Re: Harold D. Thompson Regional Water Reclamation Facility (HDTRWRF)
Lower Fountain Metropolitan Sewage Disposal District (LFMSDD)

Submittal No.:	03200-009
Date of Submittal:	June 6, 2011
Title:	Foundation Plan & Base Slab Reinforcing for Secondary Clarifiers, Drawings P14, P15
Specification Section:	03200
Manufacturer:	Dalco Industries, Inc.

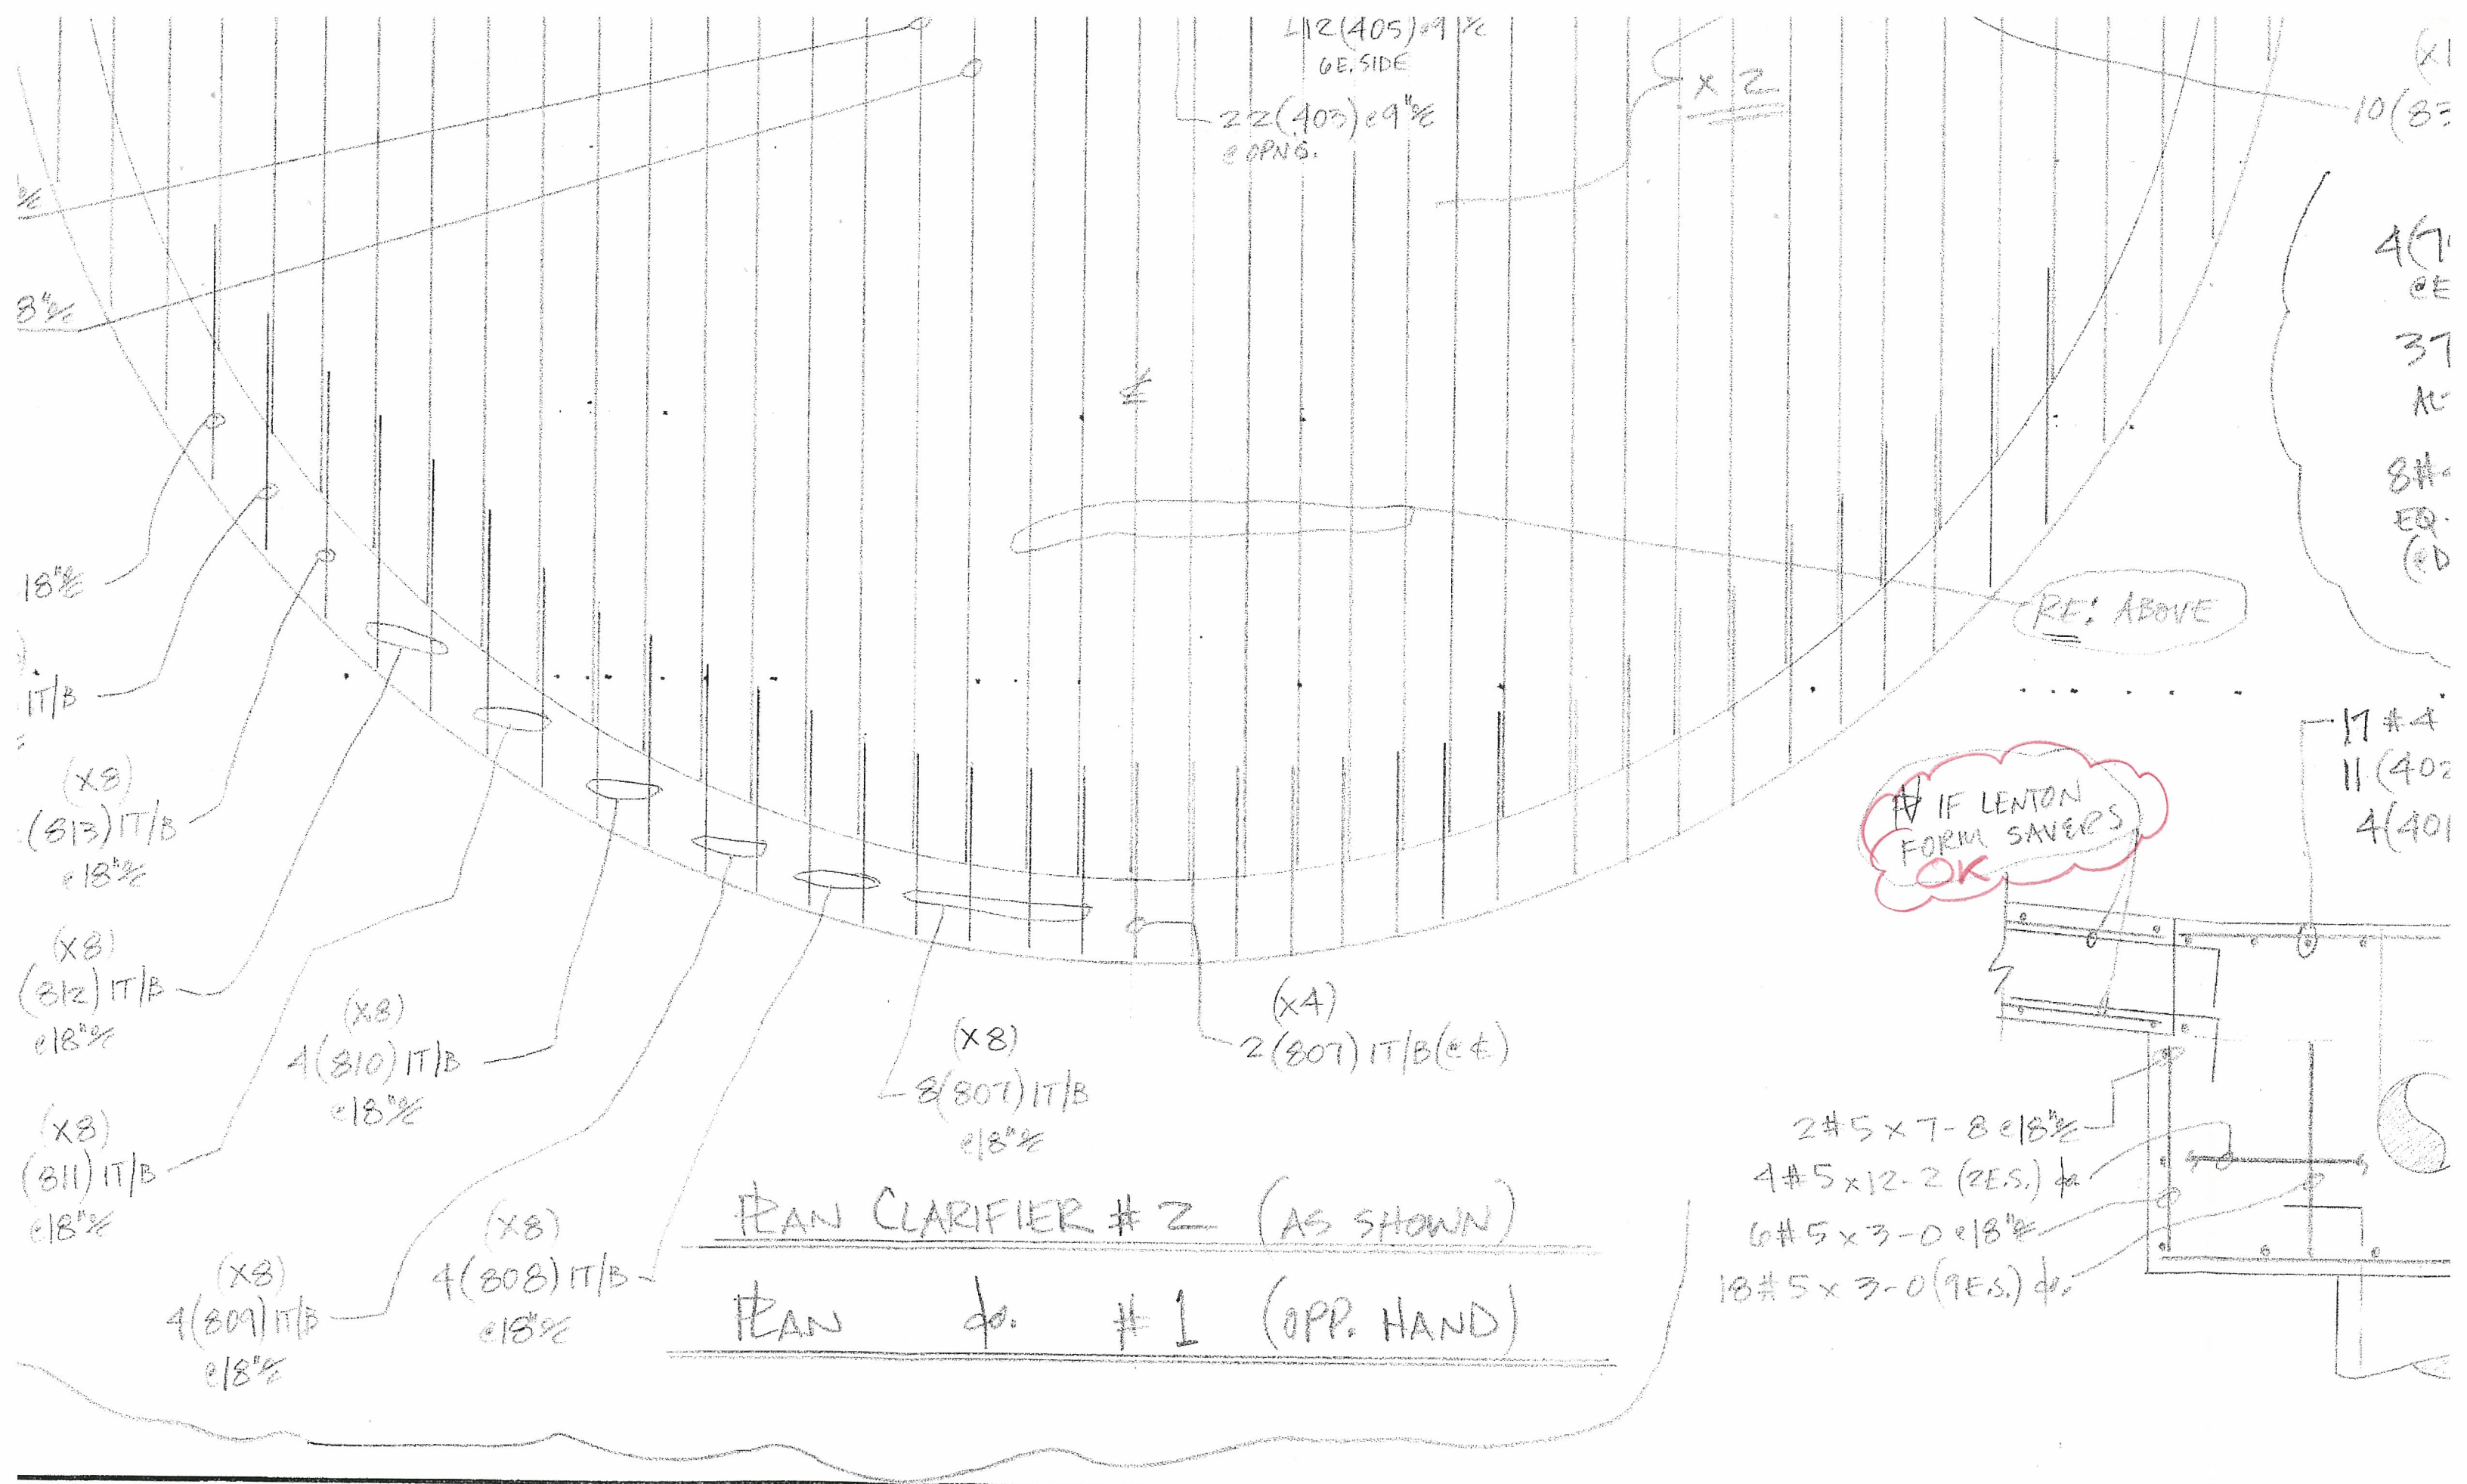
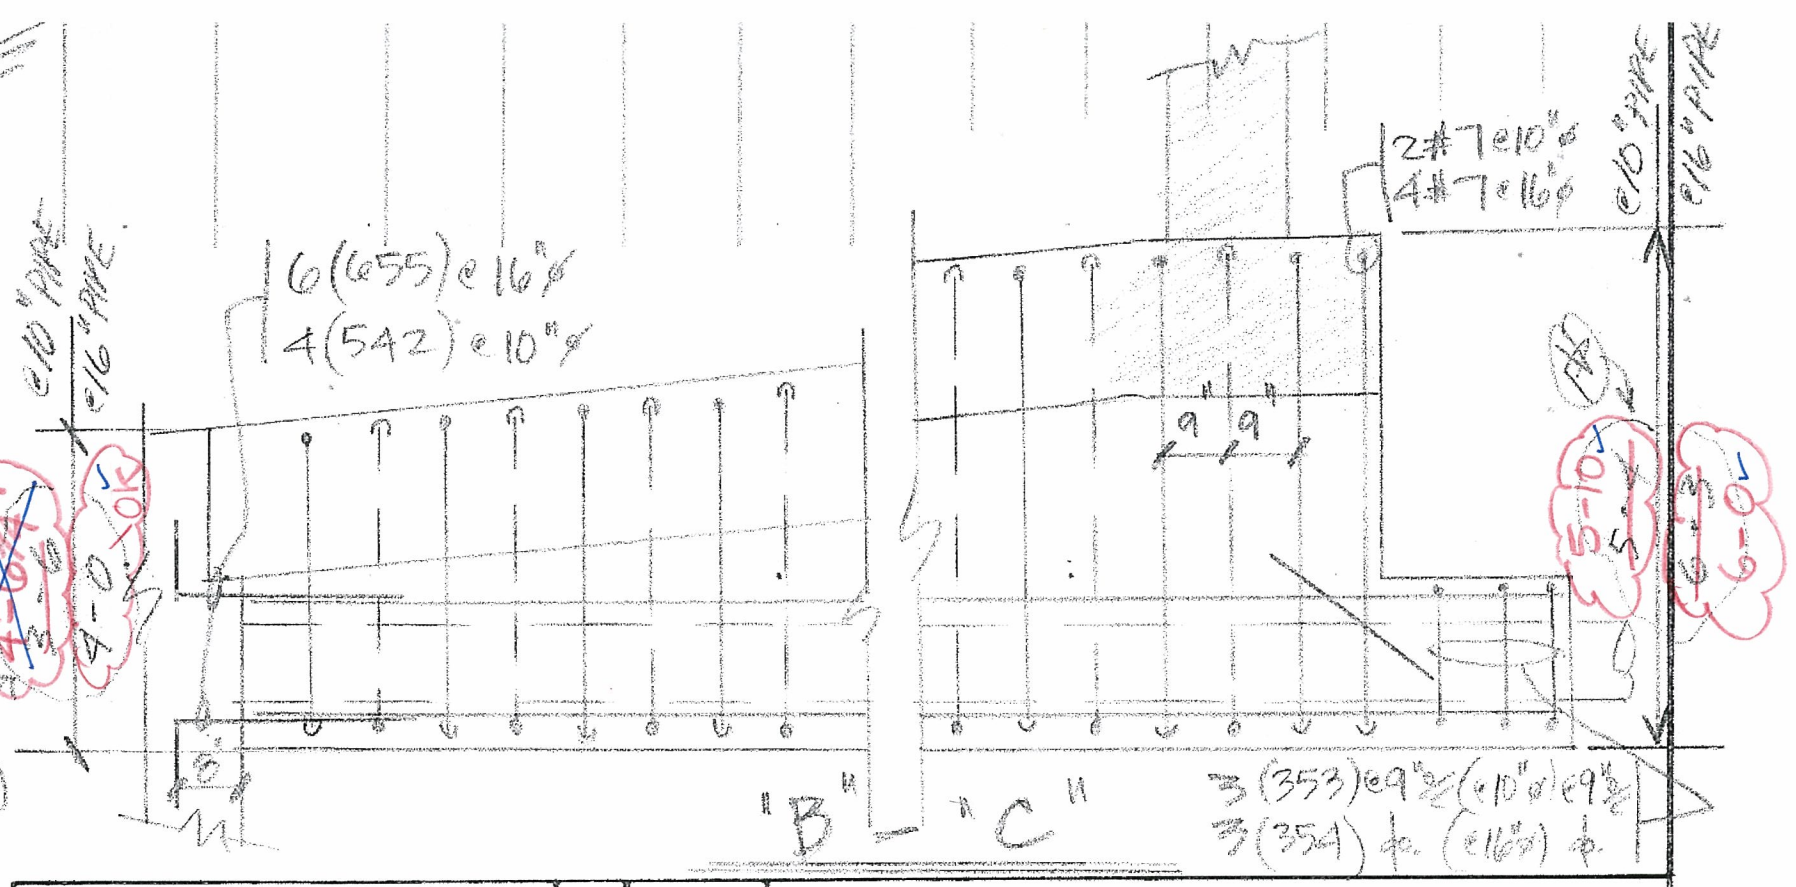
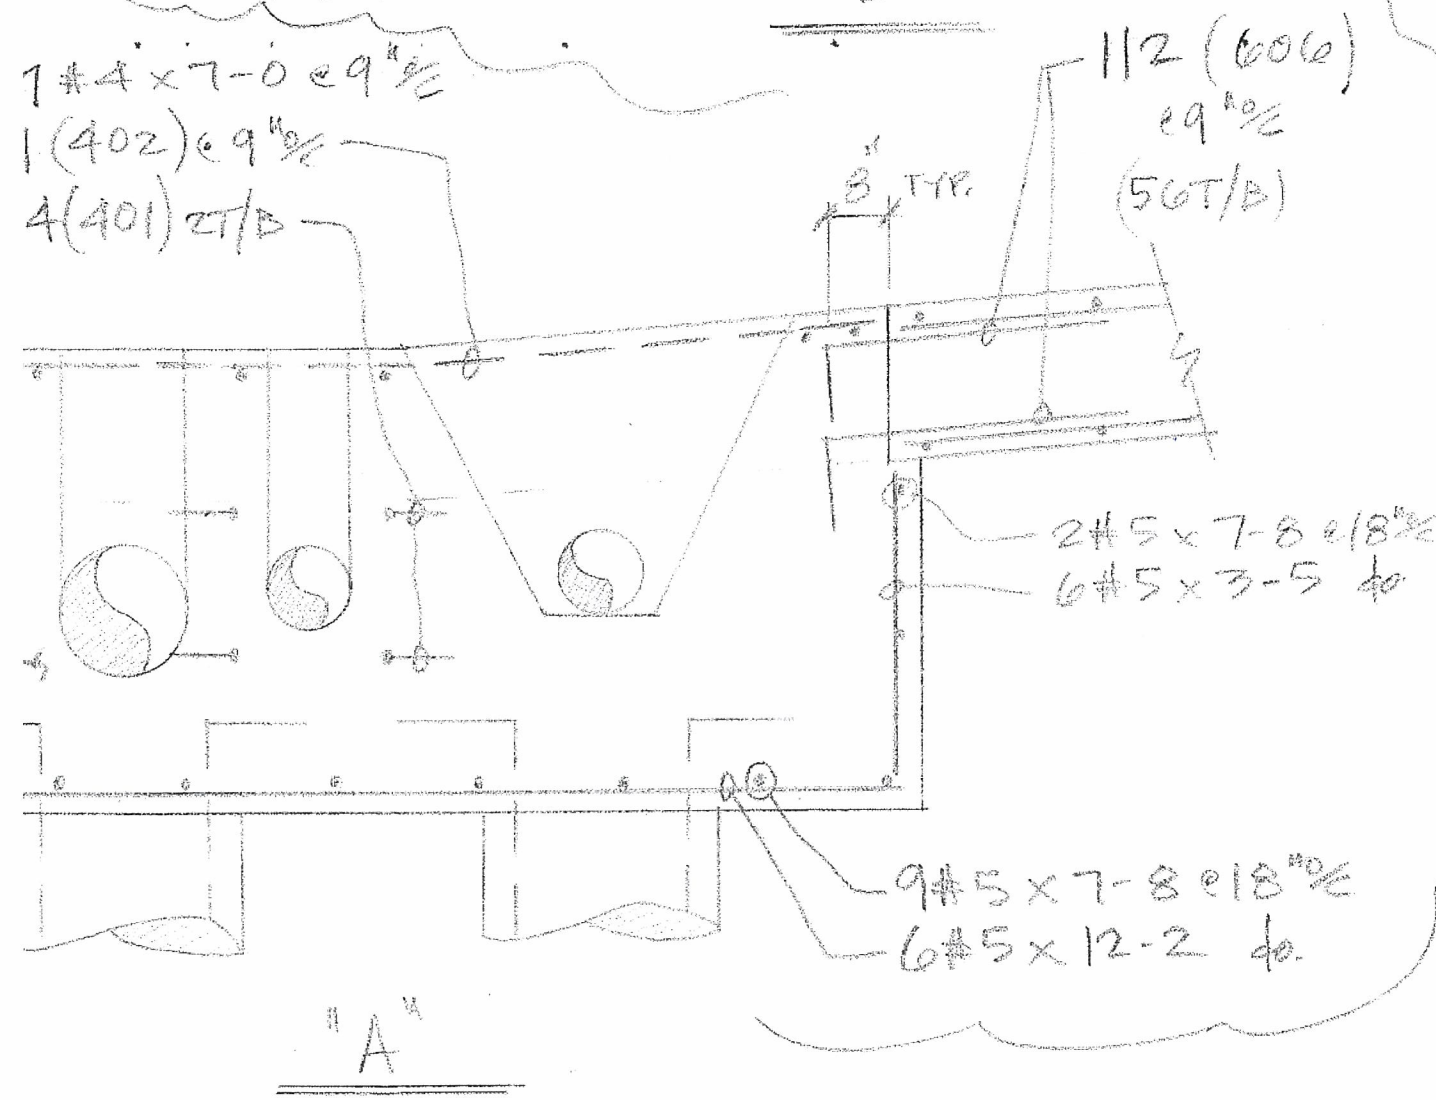
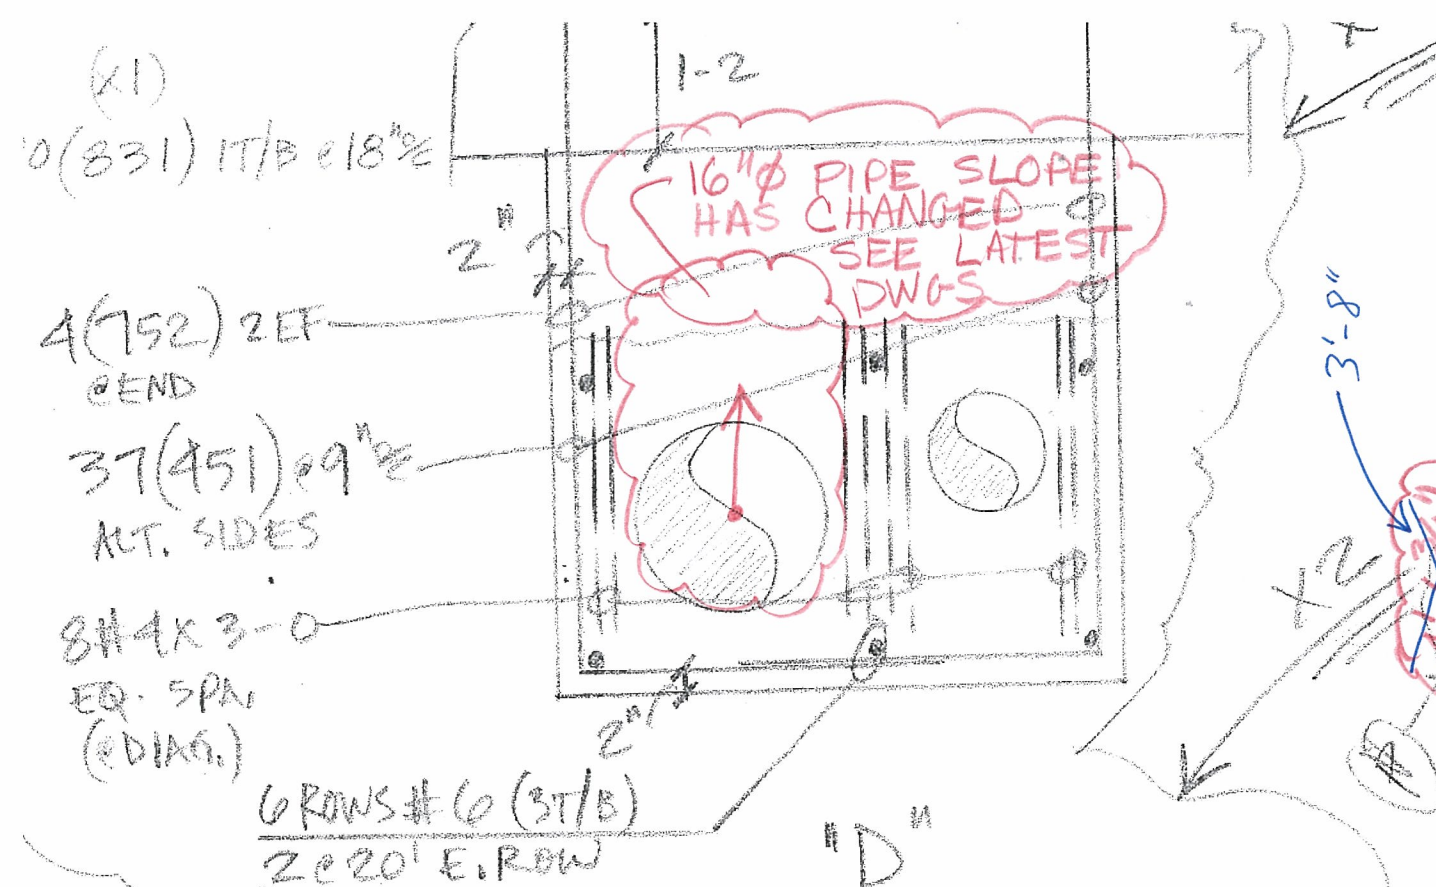
1. Included with this letter are scanned copies of the submittal drawings P14 and P15 with handwritten comments in **red**. As these comments are relatively minor in nature, a complete resubmittal for these items is not required at this time. Please ensure that all handwritten comments are satisfactorily addressed prior to fabrication, delivery and placement of the reinforcing steel.
2. Please refer to RFI-010 delivered to WGCC on June 13, 2011 regarding dimensional information for dowels associated with the Form Saver installations.
3. Please closely coordinate with the clarifier equipment supplier to ensure that all required equipment anchors and/or embedments are installed in strict accordance with the supplier's instructions.
